Access Compliance Report

Public Rights-of-Way

Intersection ID: N/A	Main Street: SUTHER_RD	Cross Street: SANDBURG_AV	Location: E
ADA ID: 7D2B16D8BB1C	Ramp Type: Directional1	Initial Pass/Fail: Fail	Overall Compliance: No
		Severity Score: 12.5

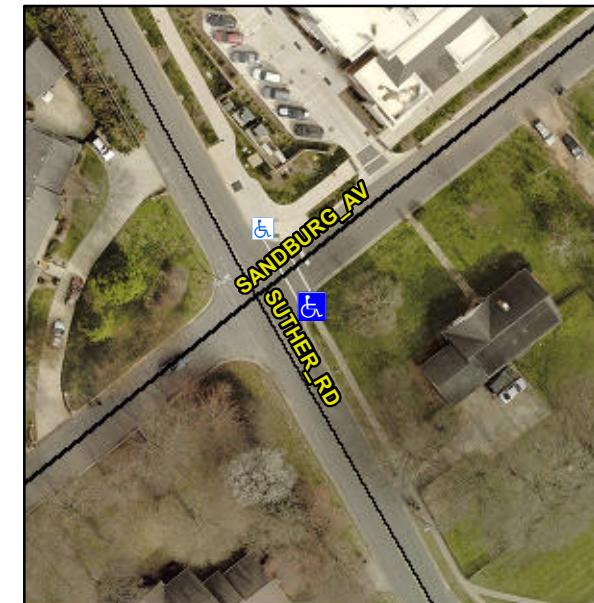
R304.5.3

Compliance	Description	Data	Compliance	Description	Data
N/A	Ramp Length (in)	49.0	N/A	Grade Break?	N/A
Yes	Ramp Width (in)	48.0	N/A	Grade Break Slope (%)	0.0
Yes	Ramp Slope (%)	1.7	N/A	Grade Break XSlope (%)	0.0
No	Ramp XSlope (%)	5.8			
N/A	Flare Type LT	N/A	N/A	Flare Type RT	N/A
N/A	Flare Slope LT (%)	N/A	N/A	Flare Slope RT (%)	0.0
N/A	Flare Traversable LT?	N/A	N/A	Flare Traversable RT?	N/A
N/A	Landing Length (in)	0.0	N/A	DWS Provided?	N/A
N/A	Landing Width (in)	0.0	N/A	DWS Contrast?	N/A
N/A	Landing Slope (%)	0.0	N/A	DWS Length (in)	N/A
N/A	Landing X Slope (%)	0.0	N/A	DWS Full Width?	N/A
N/A	Landing Curb? (Y/N)	N/A	N/A	DWS Offset LT (in)	N/A
N/A	Shared Landing?	N/A	N/A	DWS Offset RT (in)	N/A
N/A	Gutter Ponding?	0.0	N/A	Gutter Slope (%)	N/A
N/A	Gutter Lip Ht (in)	0.0	N/A	Gutter X Slope (%)	N/A
N/A	Painted X Walk1?	Yes		Road Slope (%)	2.5
	X Walk 1 Direction	To NW		Road X Slope (%)	1.5
	X Walk 1 Width (in)	87.0		Clear Space?	N/A

Remove & Replace Entire Ramp.
